APPEAL SUMMARY

Appeal ID: 22195	Project Address: 203 NE Grand Ave
Hearing Date: 12/11/19	Appellant Name: D. Michael Jones
Case No.: B-006	Appellant Phone: 5039521512
Appeal Type: Building	Plans Examiner/Inspector: Brian McCall
Project Type: commercial	Stories: 8 Occupancy: R-2, S-2, M, B Construction Type: 3-A, 1-A, (5 over 3)
Building/Business Name: Fairfield Residential Mixed-Use	Fire Sprinklers: Yes - NFPA 13, all interior environ, some exterior walls
Appeal Involves: Erection of a new structure	LUR or Permit Application No.: LU-18-191719 DZM
Plan Submitted Option: pdf [File 1] [File 2] [File 3] [File 4]	Proposed use: Residential/commercial retail

APPEAL INFORMATION SHEET

INSTALLATION: FIRE RATED 1900A LOUVER

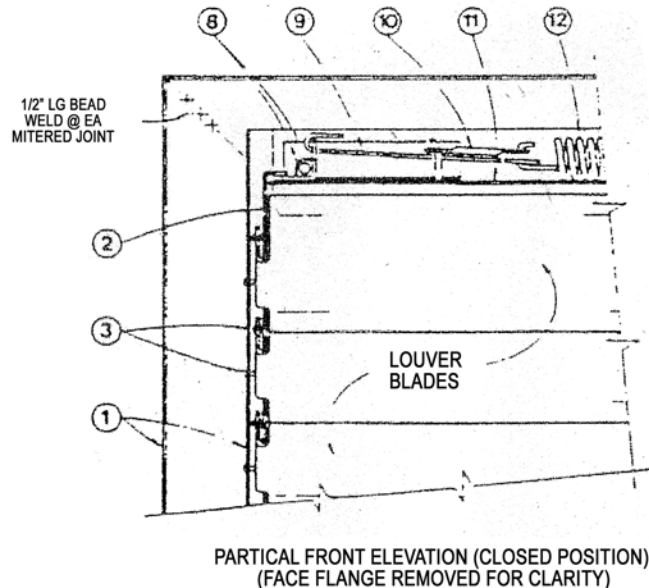
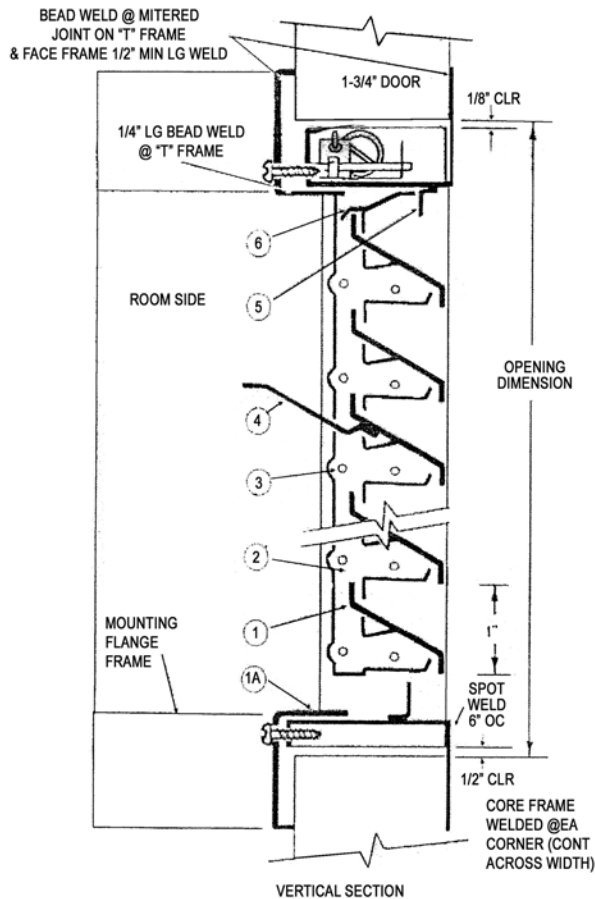
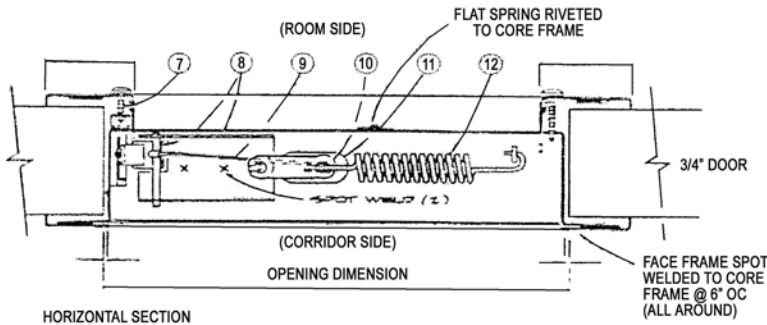
Proposed Design The design proposes to utilize the exception under 703.8.2 achieve ¾ hour-rating in lieu of rated openings on fixed lite windows and door openings. Doors will be fitted with closers to ensure they remain in closed position. Louvers below windows that are in the hazard area will have ¾ hour-rated walls behind, (louvers are a condition of approval for design review so will be expressed on the finished wall). Louvers above windows in the hazard area will have dampers on fusible links rated for ¾ hours, (see attached product data and FLS drawings).

1. Type 13 water curtain sprinkler protection at non-fire rated openings in buildings with vertical exposure on separate lots: Granted provided windows are non-operable and sprinklers are spaced not

more than 6 feet apart and placed a minimum of 6 inches and a maximum of 12 inches from the opening (s) and a maximum of 12 inches below the ceiling. Sprinklers are to be installed on the occupied side of the openings. A separate permit from the Fire Marshal's Office is required.
